Assessing new nuclear power
station designs

Generic design assessment of
Hitachi-GE's Advanced Boiling
Water Reactor

Assessment report - AR04
Gaseous waste

December 2017

Figure 5: Mean normalised annual gaseous carbon-14 discharges from BWRs 2005 to 2013
Pink line shows normalised UK ABWR estimated annual gaseous carbon-14 discharges

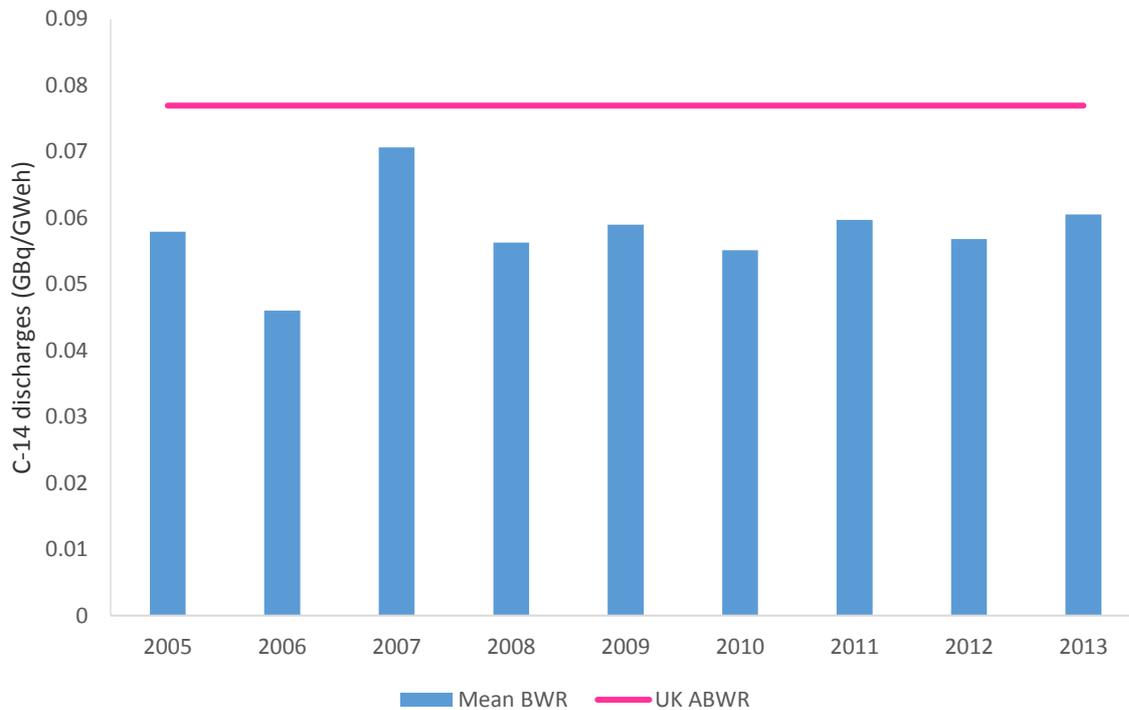
Estimated annual discharges of gaseous carbon-14 from the UK ABWR are higher than the mean annual discharges of gaseous carbon-14 from other operating BWRs and sit in the upper end of the range of data obtained for operating BWRs.

Hitachi-GE has assumed that all carbon-14 is discharged via the gaseous route and that none enters the liquid waste streams. This is a conservative assumption when considering radiological impact of discharges, as carbon-14 is not abated in the gaseous phase and is released to the environment. However, this assumption means that the normalised estimated discharges of gaseous carbon-14 may appear higher than normalised gaseous carbon-14 discharges from operating plants. The assumption that no carbon-14 enters the liquid waste streams is discussed further in our assessments reports on BAT (Environment Agency, 2017a) and aqueous waste (Environment Agency, 2017d) and is the subject of an assessment finding:
